Service Bulletin # 196

MODELS: Single Port Adaptables Only

SUBJECT: Can "Hang Up" and Possible Upper Bale Jam as a result of such can Hang Up.

Fig. 1

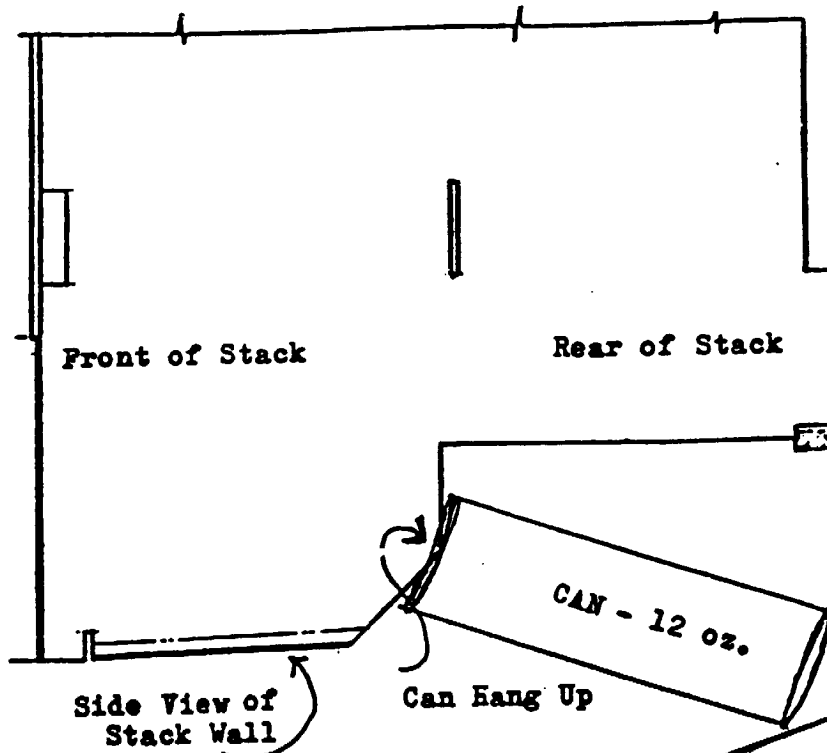
REASON: To provide Shim to prevent can hang up.

NOTE: The Shim fits either side of the stack -- there are no "lefts or rights"

INSTALLATION: Install Shim in Stack like a Flat Bottle Shim is installed.

ORDER AS: Part #B172,010,100.03 Shim, Fig. 2
